**MEETING NOTICE – SITE REVIEW COMMITTEE**

**RE:** 3794 Packerland Dr., HB-950 & HB-950-4; New 55,000 sf Warehouse Addition and Associated Site Improvements

**FROM:** Todd Gerbers, Director of Planning and Code Compliance

**ISSUE:** Discussion and action on request for a 55,000 sf., warehouse addition and associated site improvements

SECTION A-A1  
HORIZ. SCALE: 1" = 20'  
VERT. SCALE: 1" = 5'

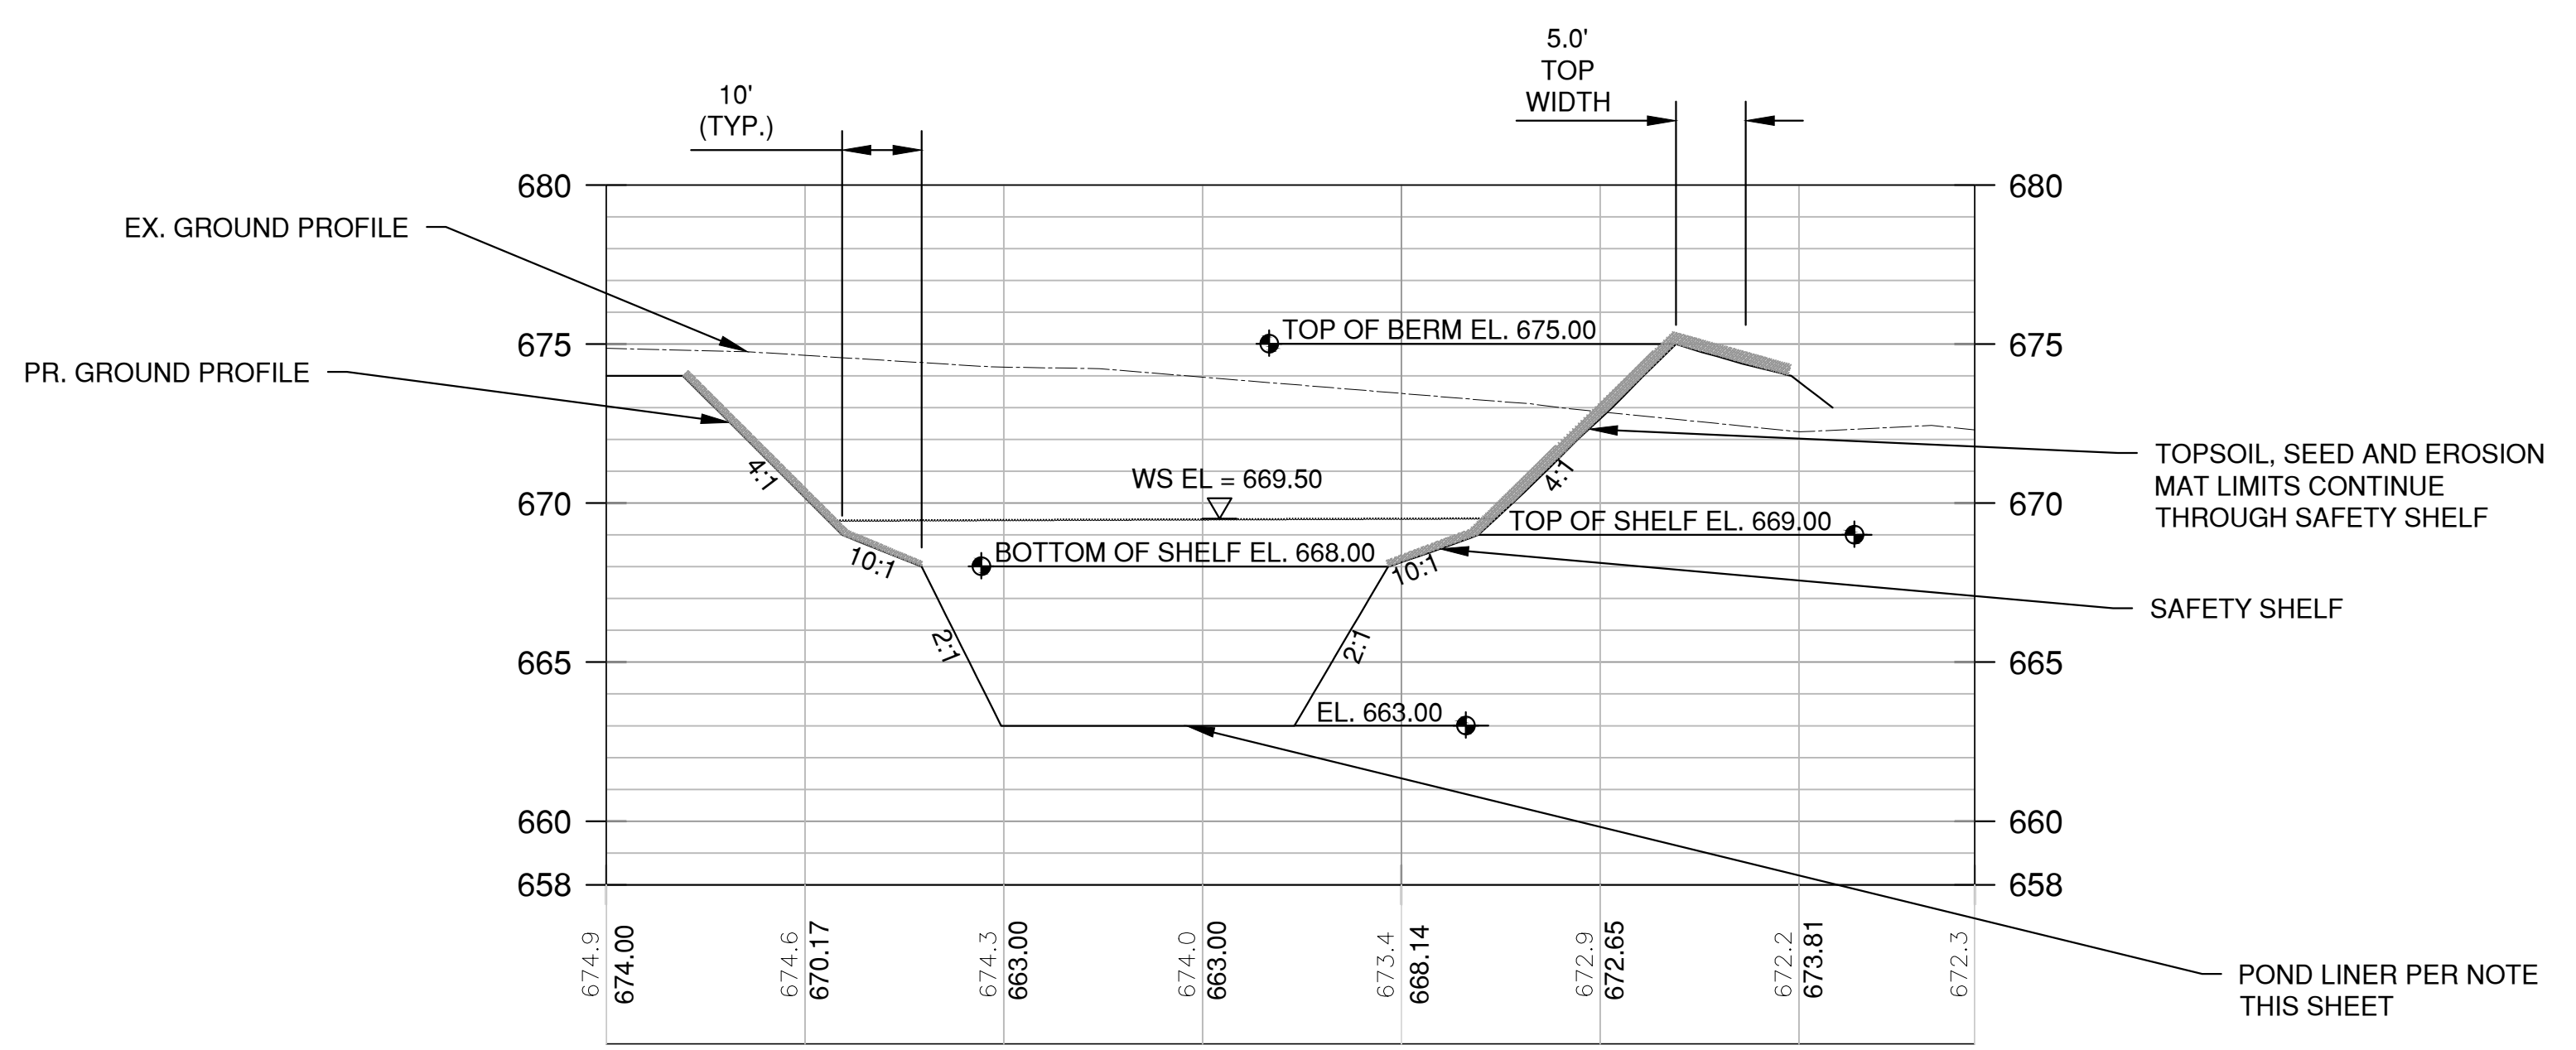
6. Submit a more detailed landscape plan to Staff for approval of the landscape areas around the street sides of the new wet detention pond to make it more of a landscape feature due to its close proximity to the public roadways.;

1 /A2.0 EAST ELEVATION 3/32" = 1'-0"

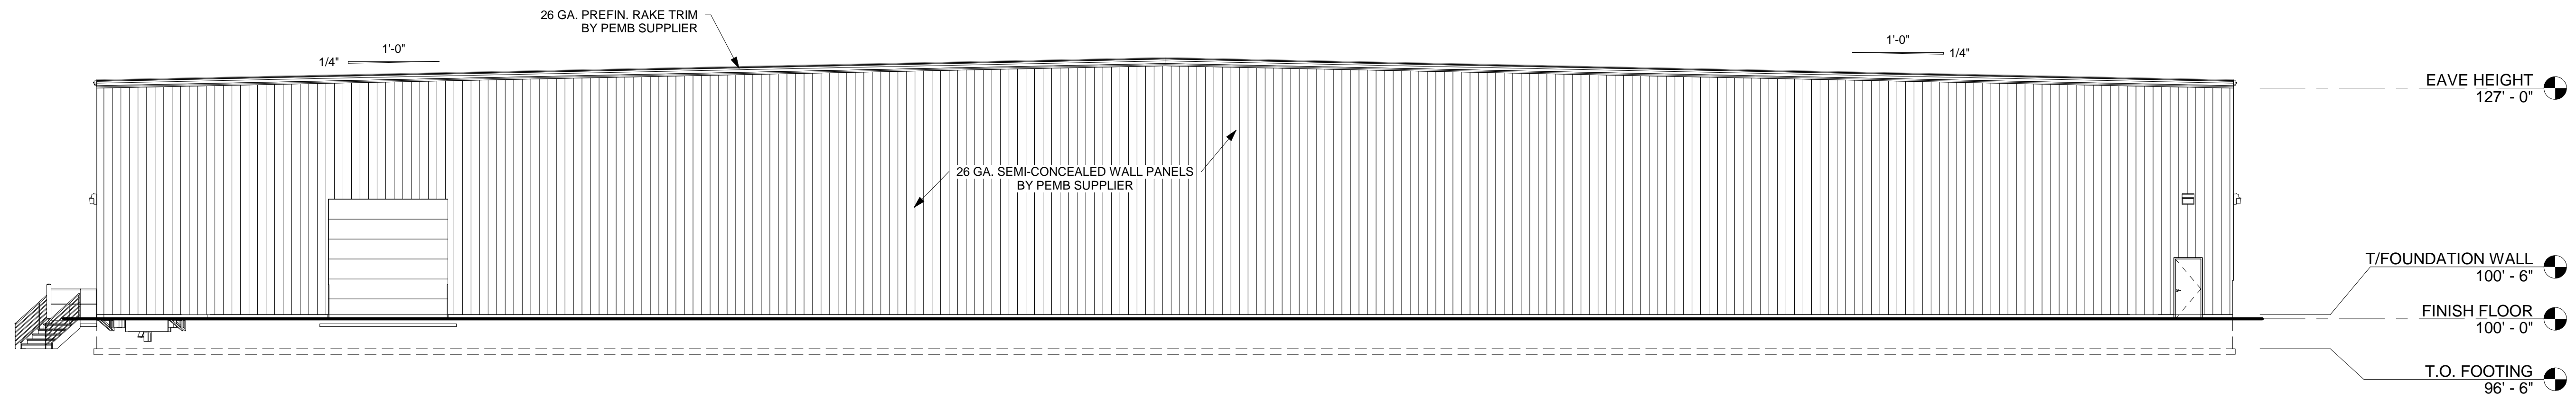
3. Coordinate with Village Fire Chief regarding the number and location of lock box(s);
4. East elevation (facing Packerland Dr.) of proposed building shall be required to comply with the minimum 35% masonry requirement prior to June 30, 2027 should the possible building addition not be constructed within 5 years (by December 31, 2026);
